RS-15-022
RA-15-008

Oyster Creek Nuclear Generating Station
Renewed Facility Operating License No. DPR-16
NRC Docket No. 50-219

Subject: Fourth Six-Month Status Report in Response to March 12, 2012 Commission Order Modifying Licenses with Regard to Requirements for Mitigation Strategies for Beyond-Design-Basis External Events (Order Number EA-12-049)

Attachment 1 OC-MISC-012, Rev 000, 20140408, Use of MAAP In Support of Flex Implementation (12 pages)

MAAP Calculation of RPV Pressure During RPV Depressurization

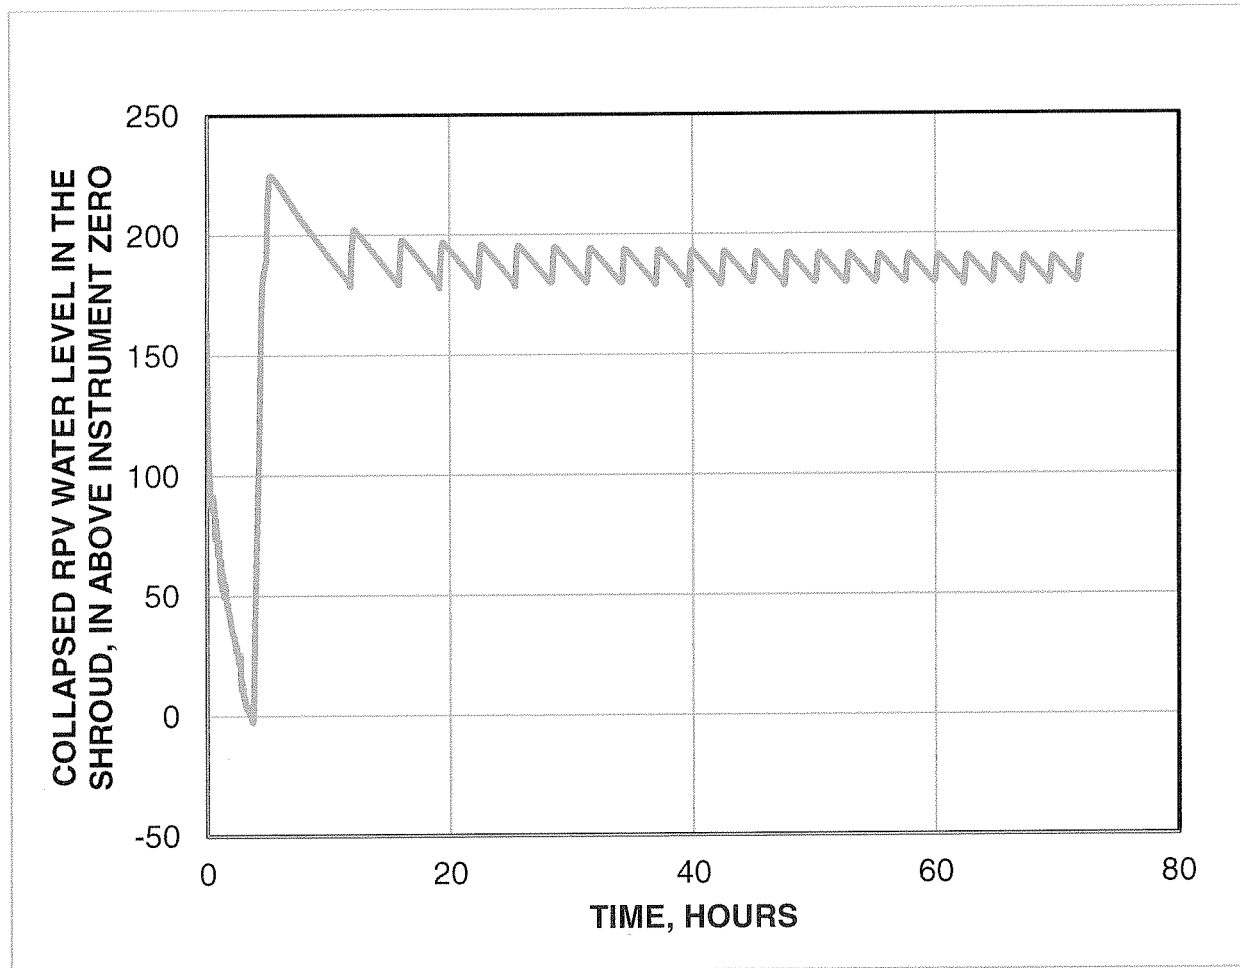
- (2) ***The collapsed level must remain above Top of Active Fuel (TAF) and the cool down rate must be within technical specification limits.***

Attachment 1A of the Oyster Creek Integrated Plan (Feb. 2013) states that the operators would commence a cooldown of the RPV at 10 min at a rate of 50°F/hr which is within the technical specifications limit of 100 °F/hr. The following plot of the RPV pressure from the MAAP analysis confirms this cooldown rate for the supporting MAAP calculation.

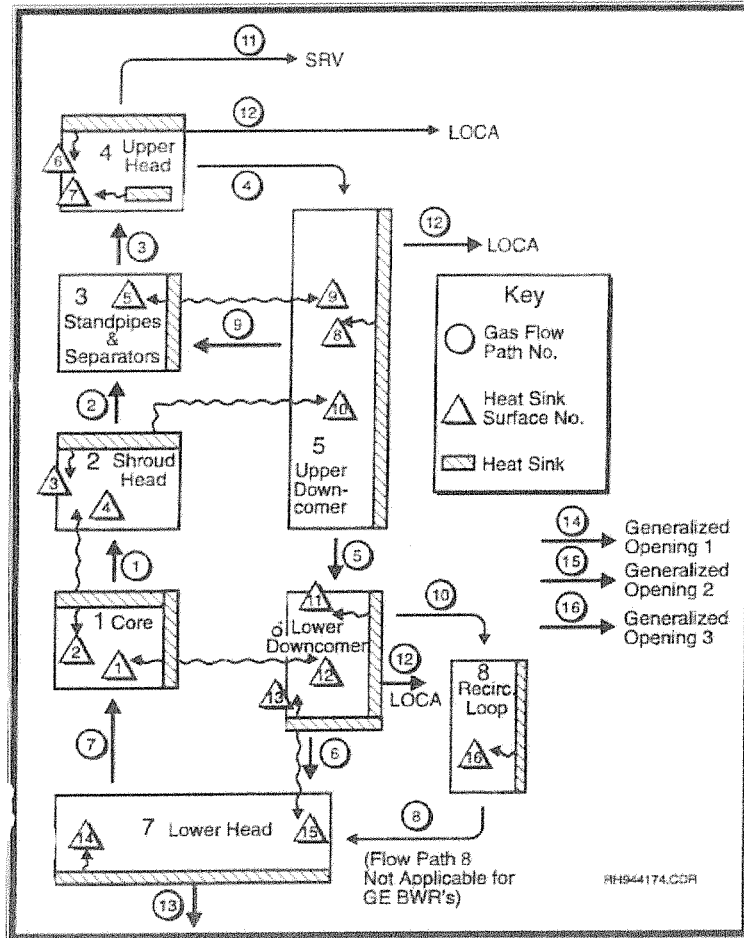
(4) ***In using MAAP4, the licensee must identify and justify the subset of key modeling parameters cited from Tables 4-1 through 4-6 of the “MAAP4 Application Guidance, Desktop Reference for Using MAAP4 Software, Revision 2” (Electric Power Research Institute Report 1020236). This should include response at a plant-specific level regarding specific coding options and parameter choices for key models that would be expected to substantially affect the ELAP analysis performed for that licensee’s plant. Although some suggested key phenomena are identified below, other parameters considered important in the simulation of the ELAP event by the vendor / licensee should also be included.***

- a. The reactor vessel nodalization is fixed by the MAAP code and cannot be altered by the user, with the exception of the detailed core nodalization. The Oyster Creek MAAP 4.0.5 parameter file divides the core region into 5 equal volume radial regions (See NCHAN) and 13 axial regions (See NAXNOD). The axial nodalization represents 8 equal-sized fueled nodes (see NROWS), 1 unfueled node at the top (see NNFT), and 2 unfueled nodes at the bottom (see NNFB). The figure below, taken from the MAAP Users Manual, illustrates the vessel nodalization scheme.
